File   SPR-1996-238

Name:   Murdock Trailer Sales – 2173 River Road

# REVIEW COMMENTS

TITLE HEADING: Murdock Trailer Sales

SITE PLAN FOR THE  
**MURDOCK TRAILER SALES FACILITY**  
LOCATED IN THE SOUTH 1/2 OF  
SECTION 36, T1N, R2W, UTE MERIDIAN  
CITY OF GRAND JCT., MESA COUNTY, COLORADO

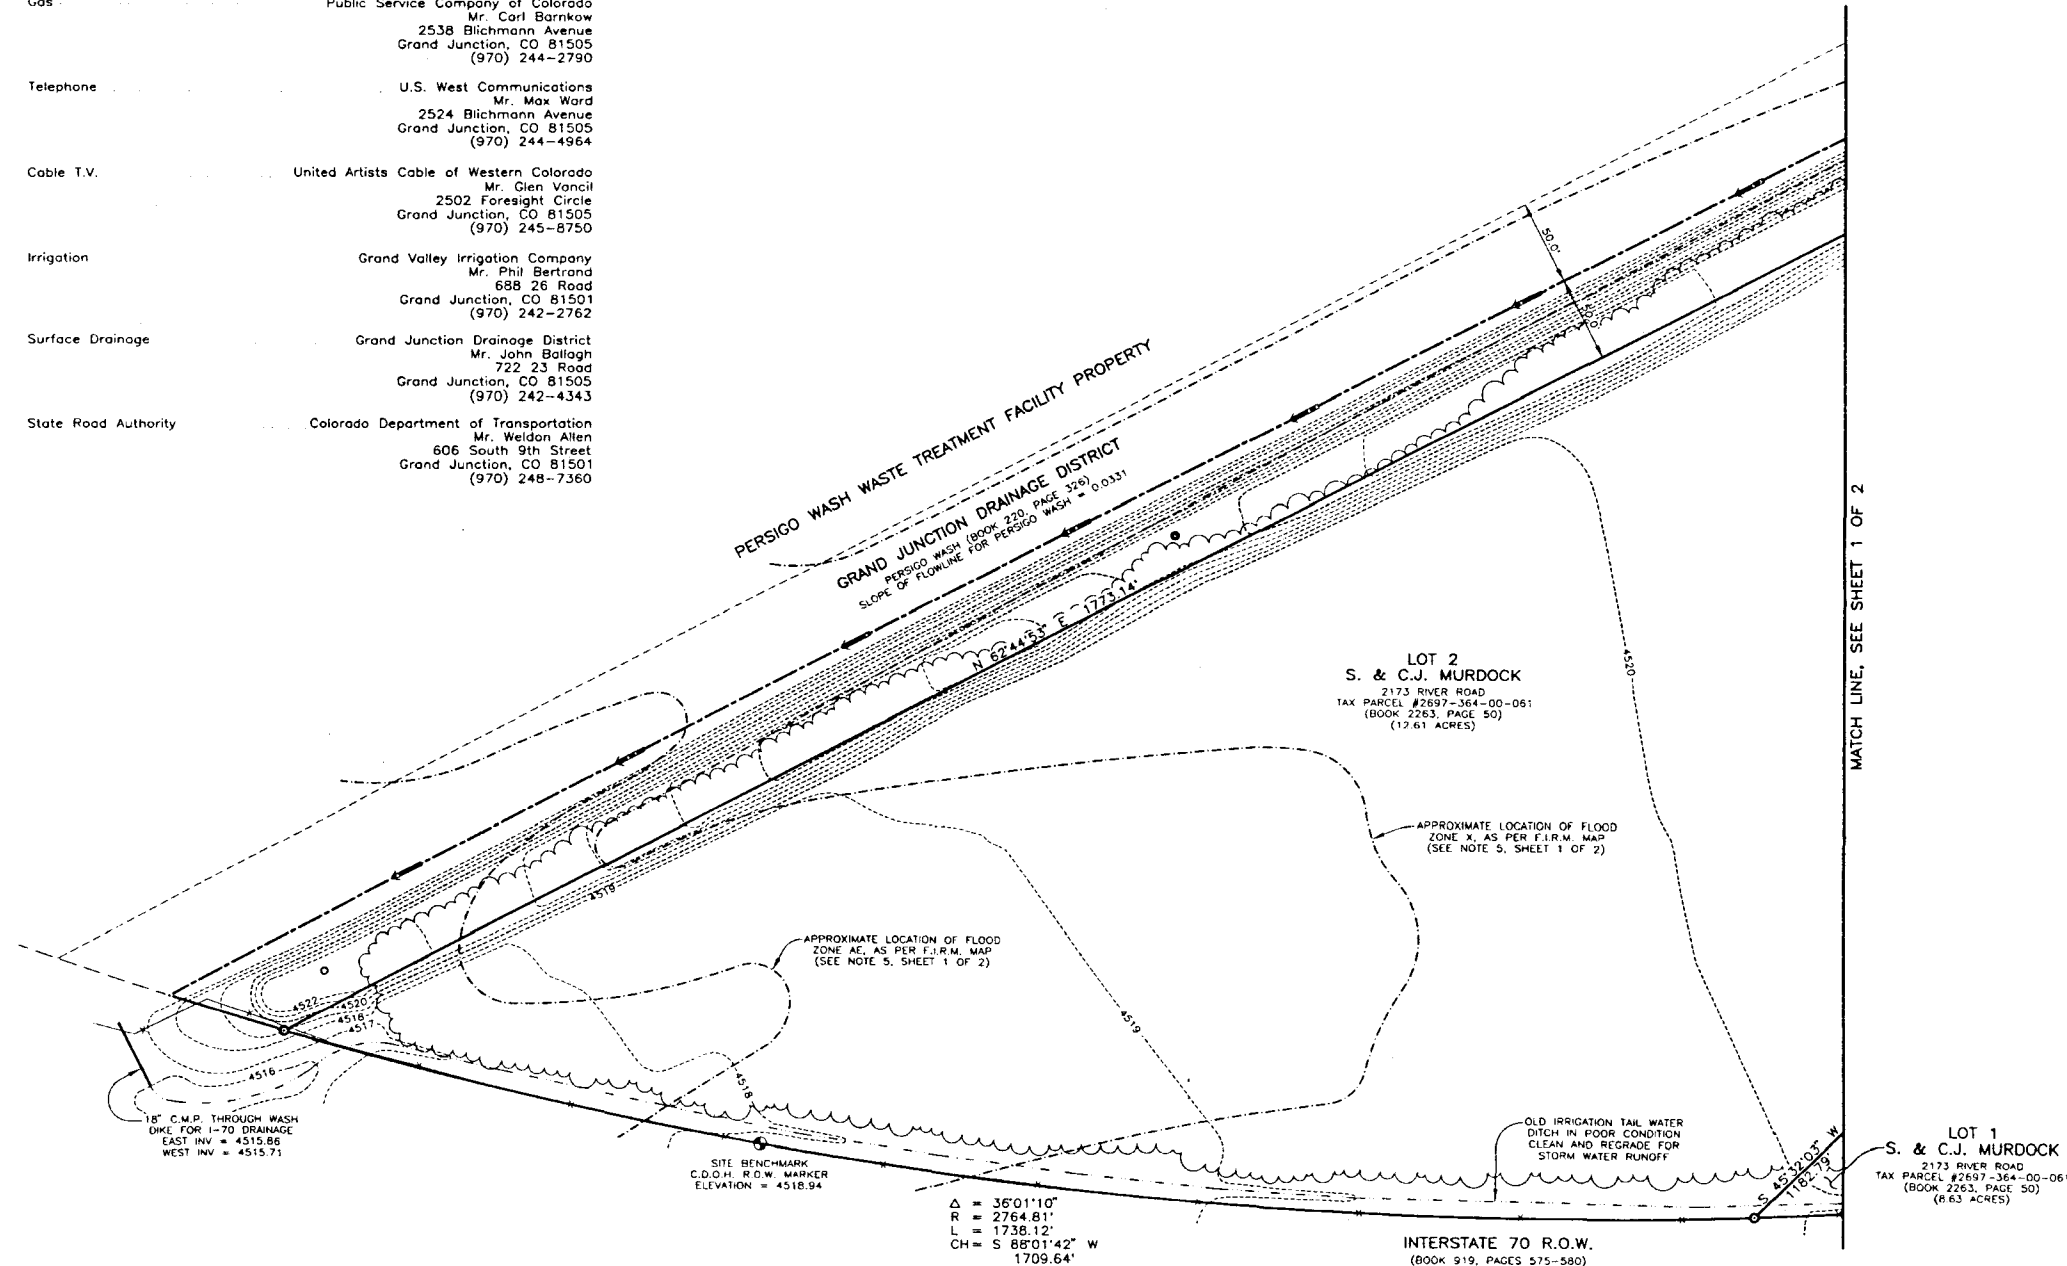
1. Parking requirement cannot be determined as it is based on total display area. Revise plan to delineate area(s) for equipment display.
2. As per Development Engineer comments, all parking and circulation areas must be paved. Is the display area by I-70 to be accessed by customers? If so, the area and the access drive to it must also be paved.

1. The drainage report and plan is acceptable.
2. Section 5-1-4 of Zoning and Development Code requires all required parking and vehicular traffic areas to be paved. This means from the street connection to the required parking and maneuvering area. Once you determine the amount of required parking, you may want to re-orient your site to minimize the amount of paved area required.

1. Place the fire hydrant at the entrance to your business along River Road.
2. A building permit clearance form is required from the Fire Department. A copy of this form must be submitted to the Building Department before you receive your building permit.

1. Revised plan to show 4 parking spaces and delineation of display area.
2. Revised plan to show paved areas.
- 3-6. Revised plan to show landscaping as agreed upon.
7. We are bidding the work and will provide the agreement prior to site plan final approval.

2. Revised plan per comment.

1. The revised plan has moved the building closer the hydrant so the hydrant can remain where it is to accommodate future plans for this property.

MURDOCK TRAILER SALES  
 2175 RIVER ROAD  
 LANDSCAPE PLAN

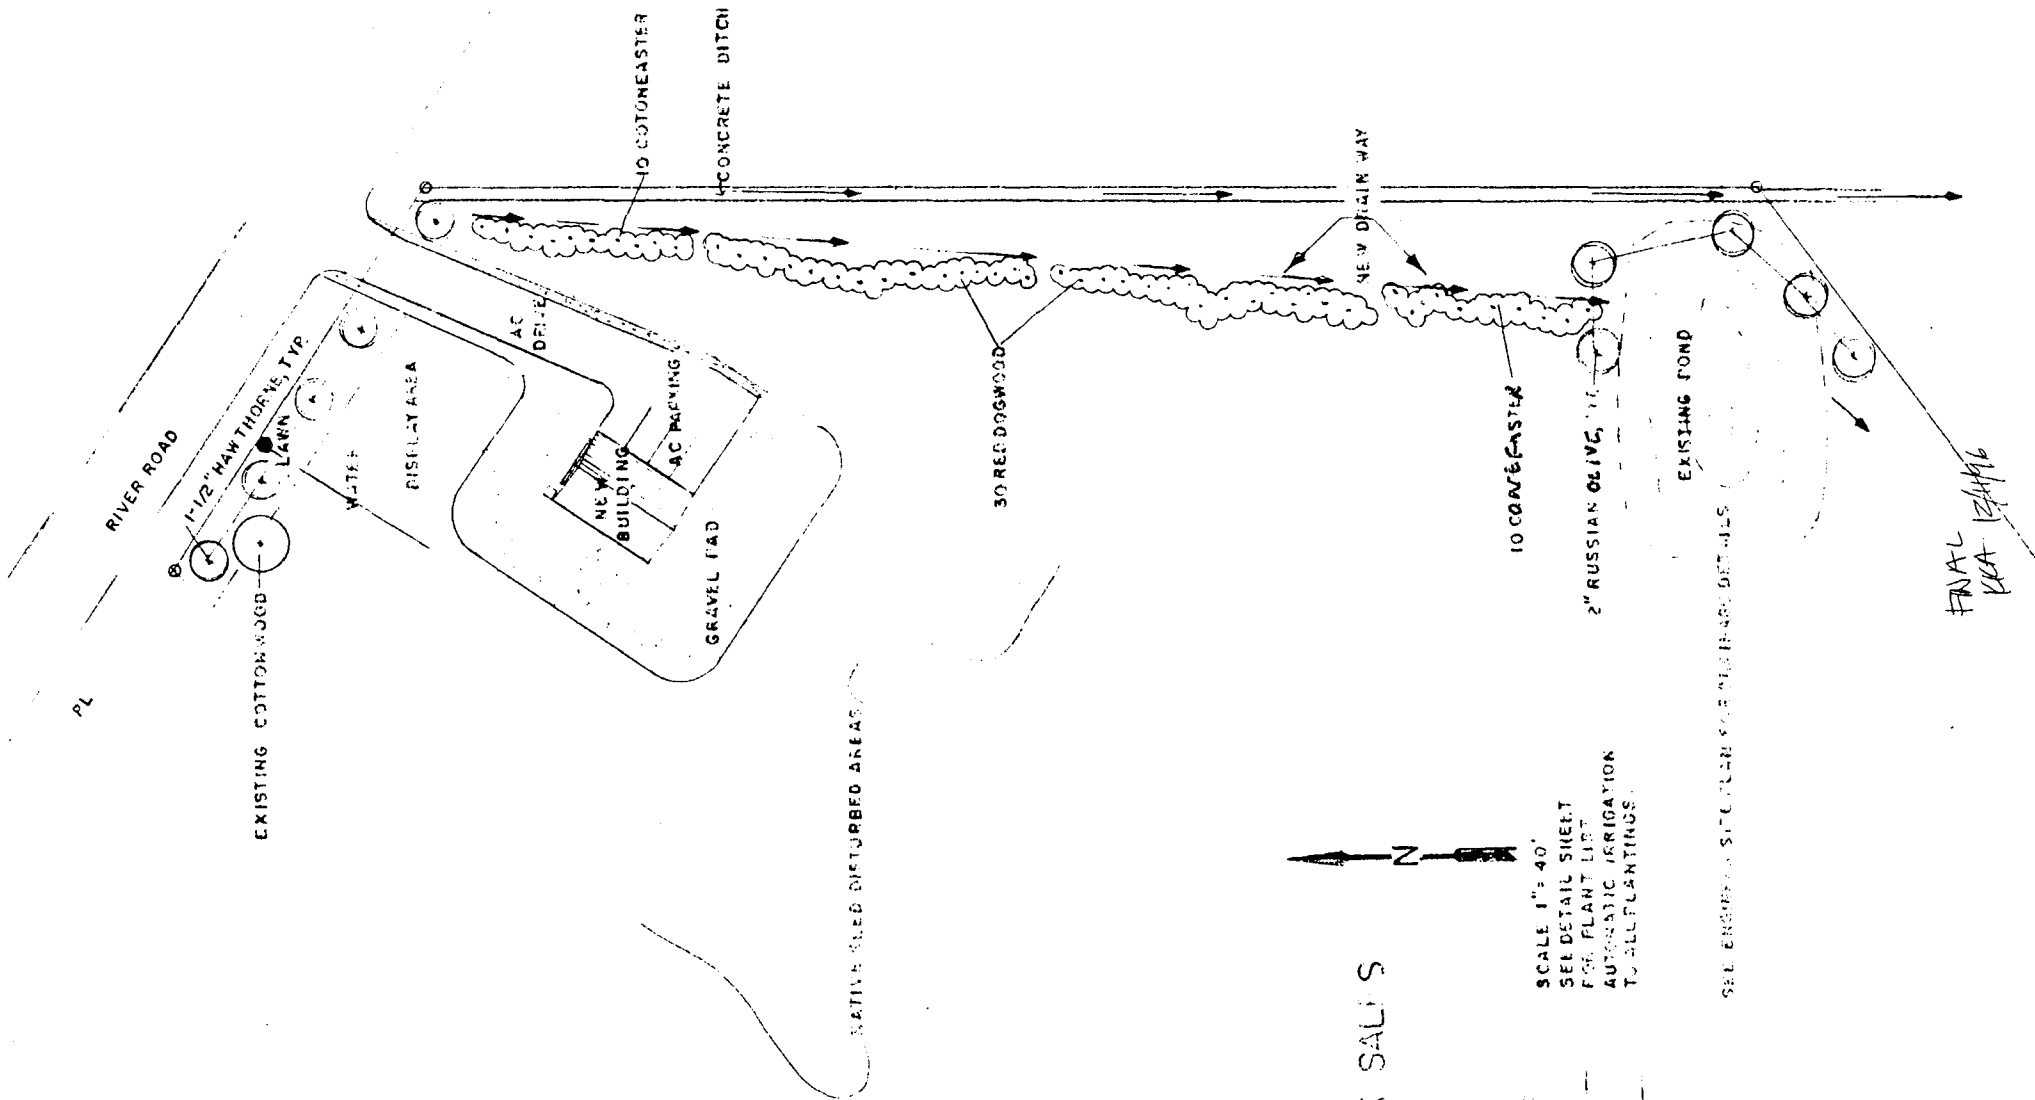
3. Landscaping in the public right-of-way between the property line and edge of pavement is required.
4. A table listing quantities, species and planting size of all proposed landscaping is required.

5. Irrigation of landscaped areas is required. Add a note to the plan that all landscaped areas will have an underground, pressurized irrigation system.

6. Based on the street frontages of Lot 1 only, the landscape requirement is 7,062 sf + 5% of the parking area (once determined). At a minimum, landscaping should be provided near the building and a row of trees planted along the I-70 frontage.
